Comments on and objection to the proposed Padbury Brook Solar Farm planning application

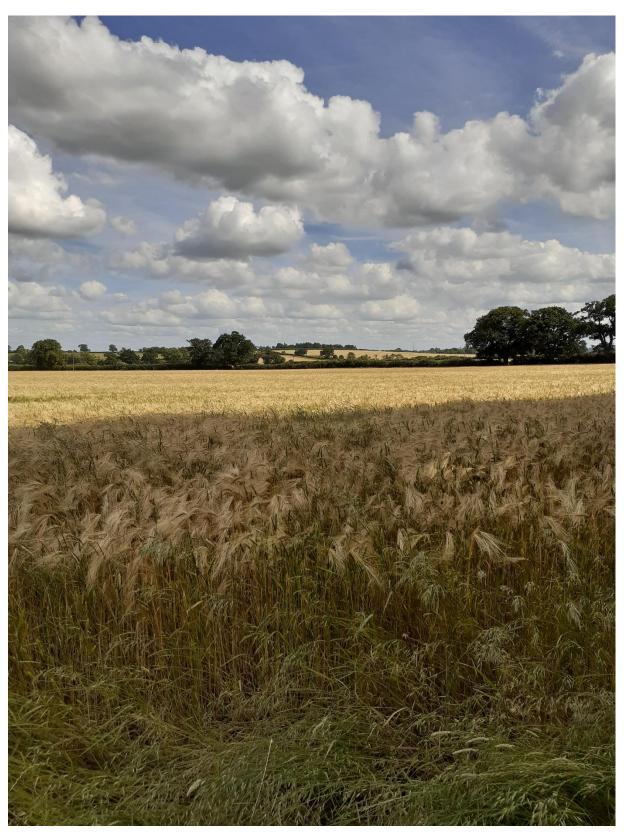
The value of the landscape lies in the far reaching views that can be obtained over undulating ground interspersed with groups of mature trees. The public views from the highway and footpath network across the open undulating vistas create a sense of space and tranquillity. This is demonstrated by the photographs below which show the existing view north-east from the footpath (PROW 371/8b/10) where it emerges from the woodland adjacent to Mill Road across one of the fields that would be occupied by the solar panels and high fencing. The corresponding view in the opposite direction is from the Godington end of the public footpath, and the public highway leading to Godington from Poundon Road. The contrast with the developer's 'after' photomontage is most striking.

This viewpoint from the point at which the Fringford to Godington foothpath (PROW 371/8b/10) enters the site from the ancient woodland is not one of the viewpoints utilised for photomontages submitted in support of the application. Although VP2 PROW 371/8b/10, looking south-west into the site has been included this is the point where the footpath leaves

the site and enters Oldfields Farm. It does not show the view towards the ridgeline at Godington, although it does reveal the openness of the landscape and the rise of the land towards the south-west away from the river valley bottom.

In contrast, VP1 which is described as 'PROW 371/8a/10 looking south towards the site' is on the other side of the ancient woodland and the road that runs through it. This is therefore of little value in assessing the effects on landscape character and visual impact of the site itself. It is not understood why this VP has been chosen, whilst the most important vista as seen from the other side of the ancient wood has not.
